# 87th & Greenwood

Early Design Guidance Meeting No. 2  
SDCI #3033218-EG  
June 3, 2019

WH Greenwood LLC

# Secondary Modulation Transformation Diagrams

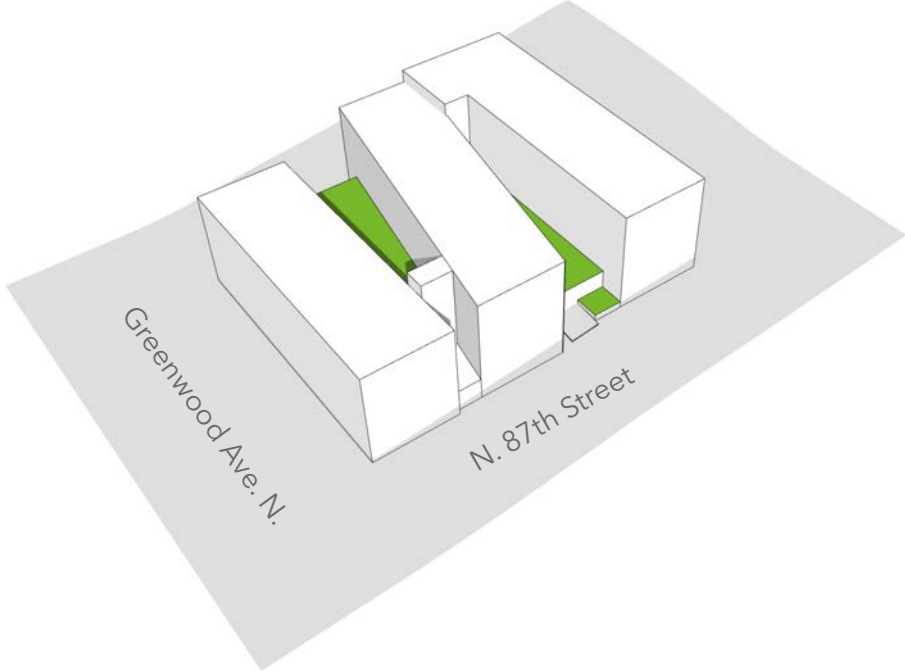
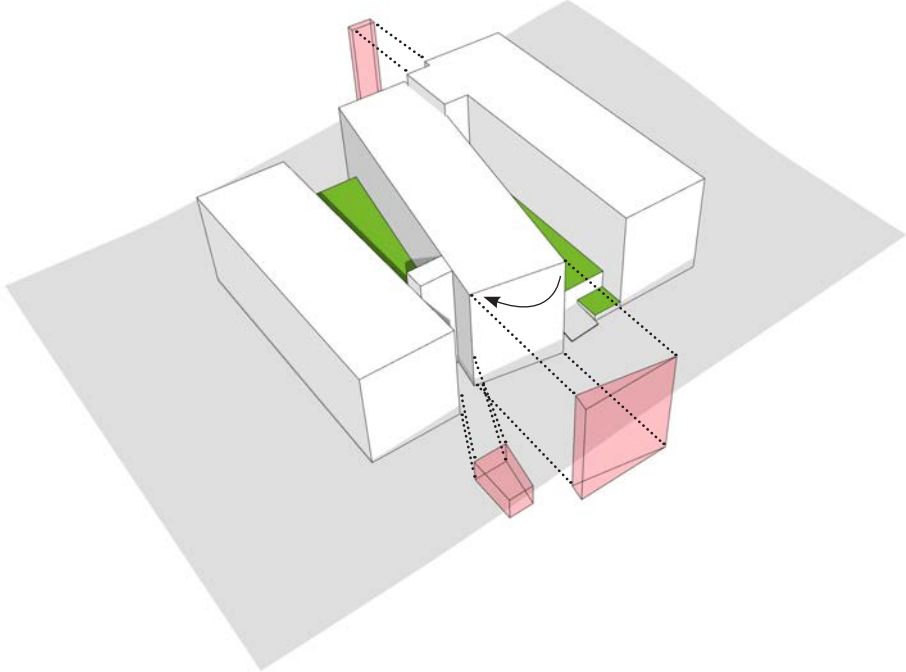
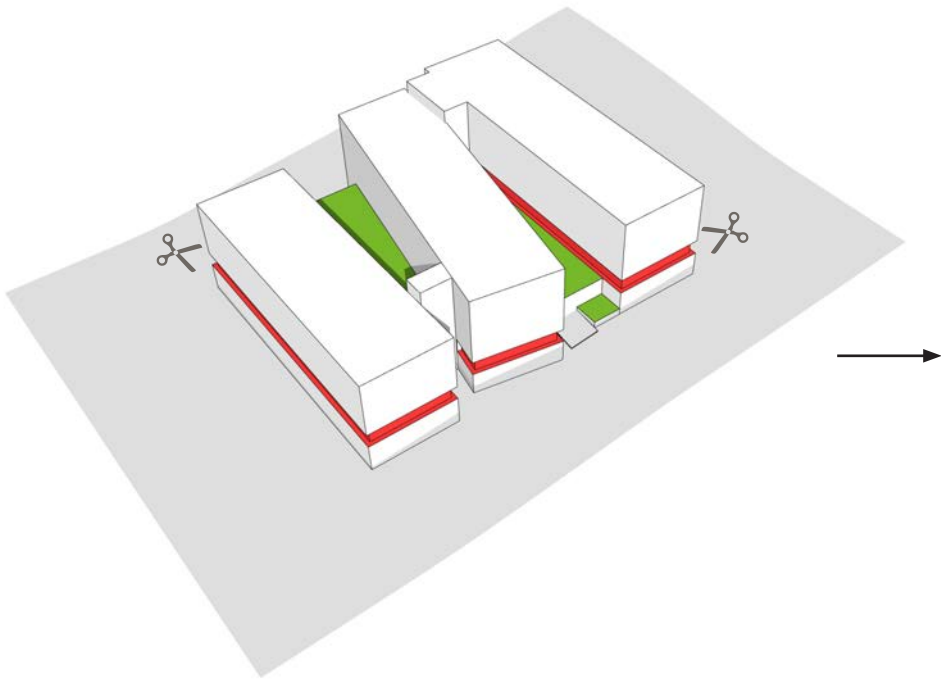
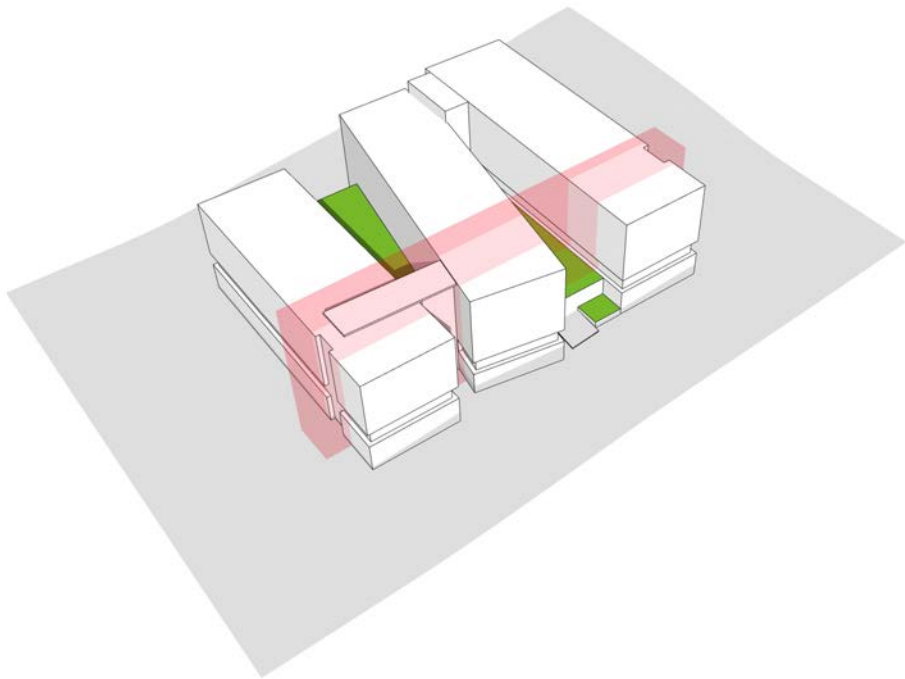
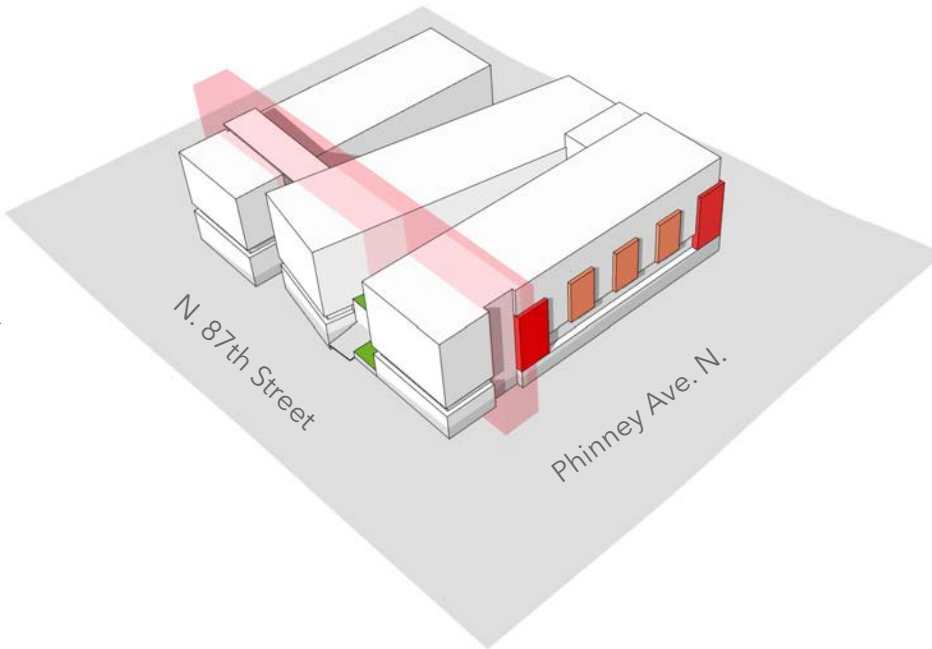
c. The Board agreed that the massing parti was strong but broke down at the northeast stair element, where the legibility of the composition became unclear. (DC2) [Refer to Diagram 2.](#)

d. The Board recommended that the middle bar hew to its own geometry rather than the property line, as this would result in a stronger and more legible massing scheme. (DC2) [Refer to Diagram 2.](#)

e. The Board was concerned that the massing moves in Option 3 would not be perceptible from street level and agreed that the base would need to be broken or revised to make this strong move legible. (CS2-II CS2-VII) [Refer to Diagram 2.](#)

a. The Board did not support the continuous and monolithic massing at this edge finding it out of scale for this street. (CS2-II-ii, CS2-II-i) [Refer to Diagram 5.](#)

c. The Board voiced their appreciation for the character sketches showing pedestrian level experience along Greenwood Avenue but were concerned as to how the more traditional character at the street-edge would carry up to the more modern expression of the residential levels above. (DC2-II-i) [Refer to Diagram 4.](#)

REVISED N. 87th STREET MASSING

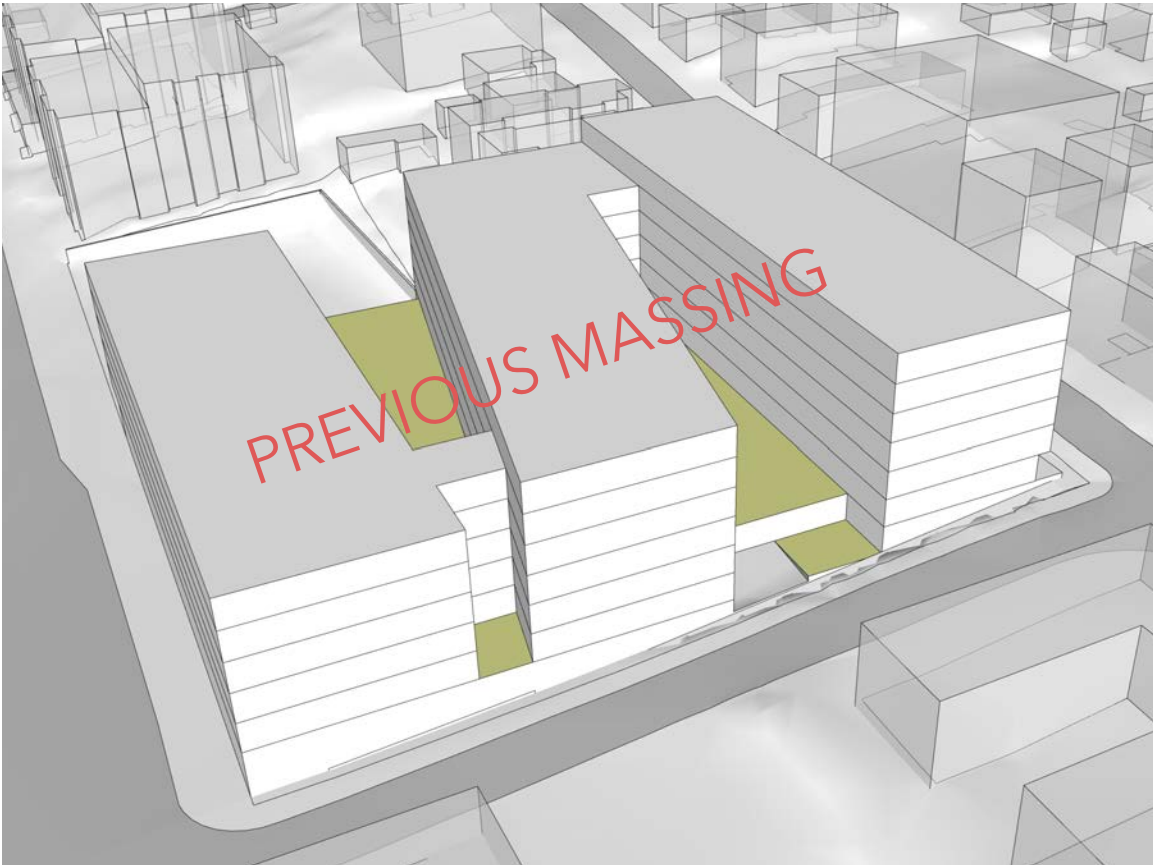
- 1** DRB FEEDBACK  
The Board recommended that the middle bar hew to its own geometry rather than the property line, as this would result in a stronger and more legible massing scheme. (DC2)  
**Response:** The massing of the central bar has been revised per the DRB's recommendation.
- 2** The Board was concerned that the massing moves in Option 3 would not be perceptible from street level and agreed that the base would need to be broken or revised to make this strong move legible. (CS2-II CS2-VII)  
**Response:** The break in building massing at the southwest "connector" stair has been extended down to the sidewalk level further emphasizing the legibility of the three-bar massing scheme from a pedestrian's point of view.

REVISED PHINNEY MASSING

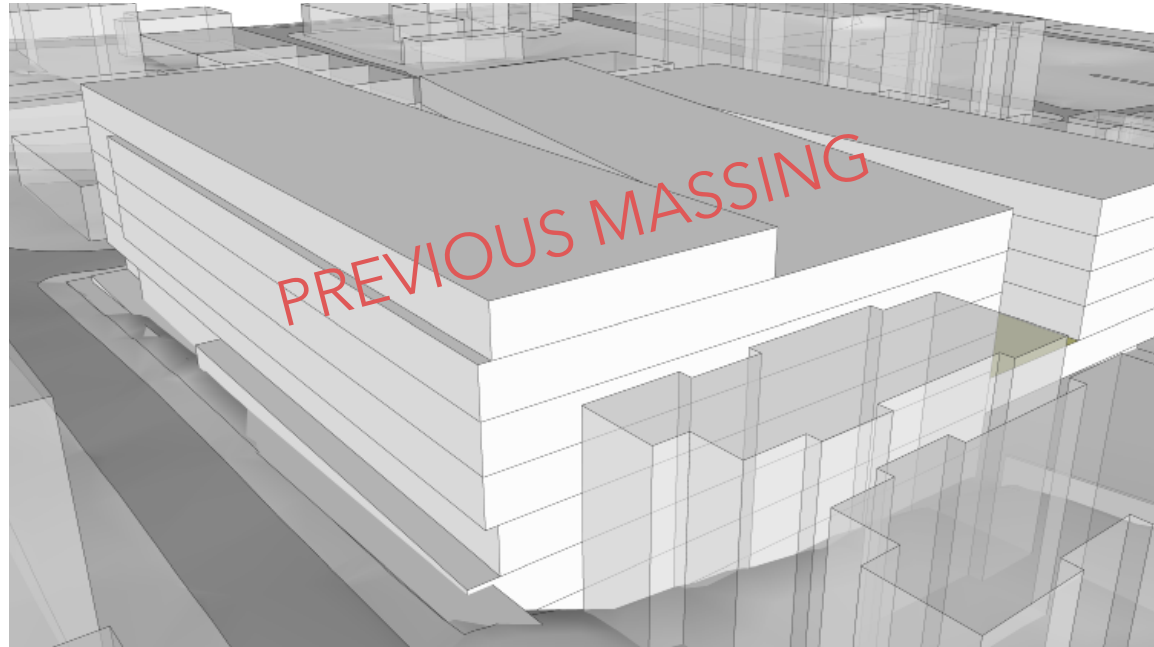
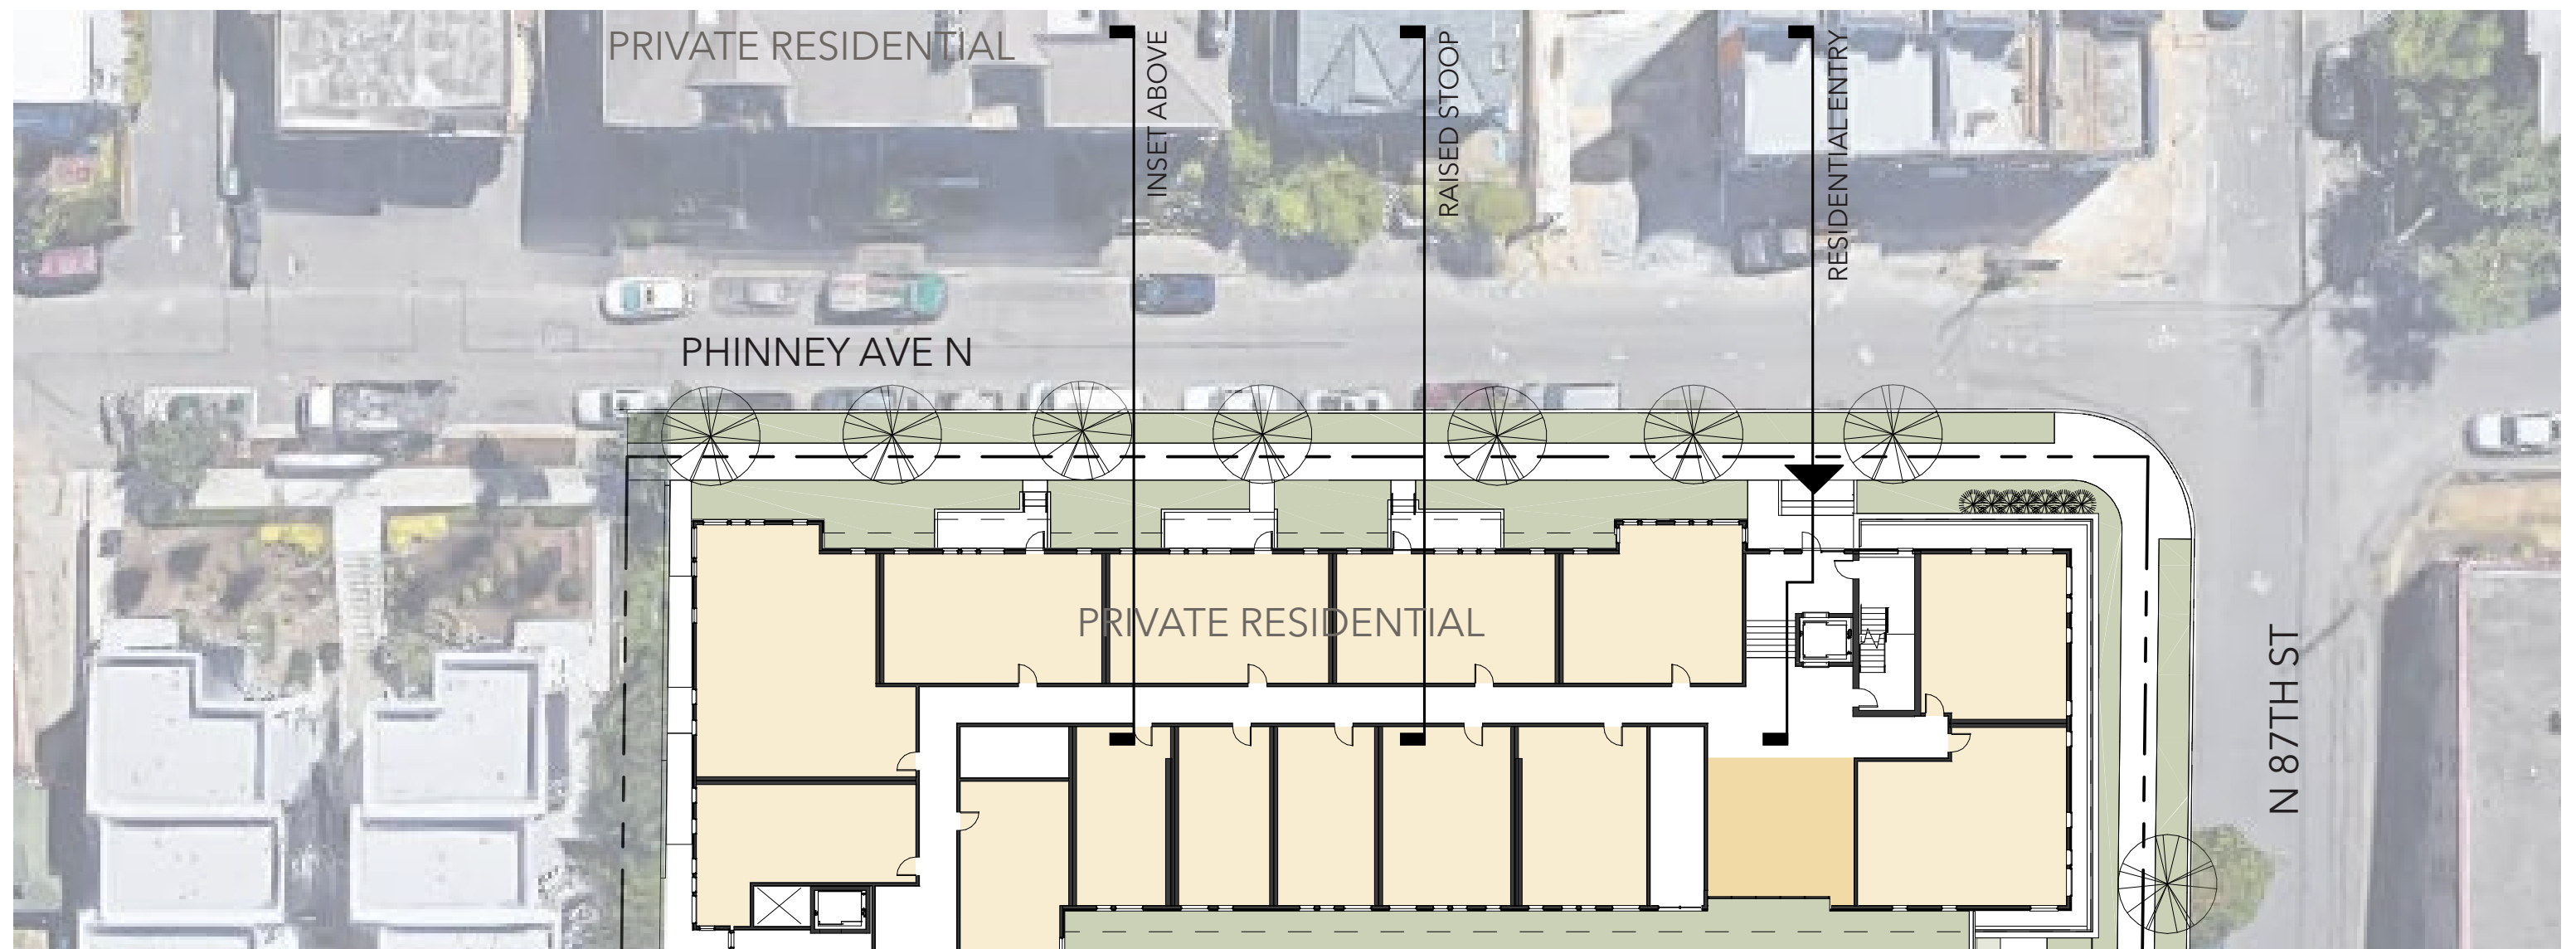
*Comment 3.a. The Board did not support the continuous and monolithic massing at this edge finding it out of scale for this street. (CS2-II-ii, CS2-II-i)*

*Comment 3.c. The Board pointed out the projects directly across the street where the height and bulk are successfully mitigated by setbacks and breaks in the massing. (CS2-II)*

*Comment 3.b. The Board agreed that the setbacks at this edge were insufficient to mitigate the bulk and scale of the massing. (CS2-II-i, CS2-VII)*

**Response:** The massing of the Phinney facade has been broken down by means of subtractive vertical articulation, relating to the pattern and scale of the adjacent Low Rise zone. Stoops aligning with this facade modulation relate to the residential character of Phinney Ave. N. This modulation is a direct response to the scale and modulation of the adjacent townhouse and residential buildings.

**Response:** The building setbacks were increased from those shown in EDG1 at the vertical modulation elements from 4' to 6'. The setback was increased at the ground level from 6' to 8' allowing for generous sized stoops that can be buffered with landscaping from the street. The street level units are now set back more than 10' feet from the sidewalk with the exception of the portions of units highlighted in Departure 1. The revised massing modulation and additional setbacks beyond code minimums on Phinney Ave. N. address the Design Review Guidelines and the DRB's concerns regarding building setback and relationship with the street. Refer to pages 53 - 55.

REVISED NORTH FACADE MASSING

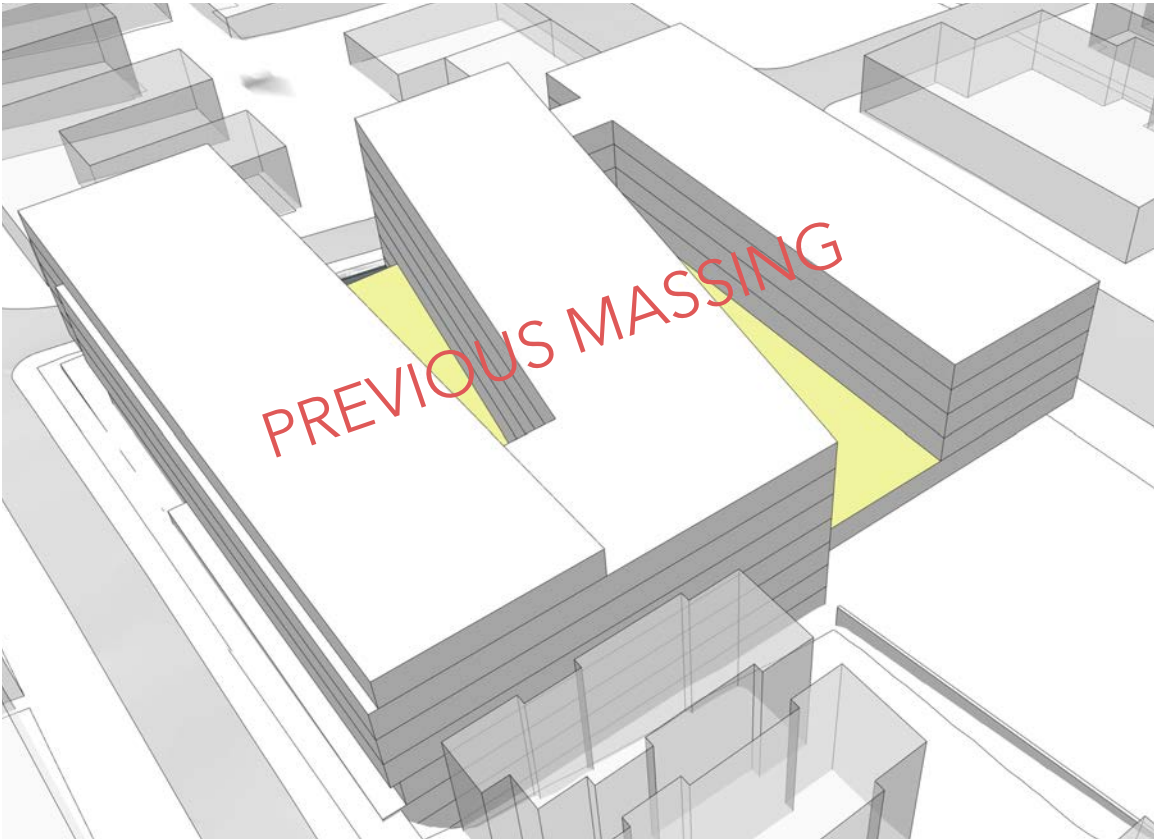
The Board agreed that the massing parti was strong but broke down at the northeast stair element, where the legibility of the composition became unclear.  
(DC2)

**Response:** The northeast connector massing has been revised. A reveal has been applied to the north elevation which allows the eastern and central bars to read as discreet masses. Contrasting materiality has been proposed for the northeast connector mass.
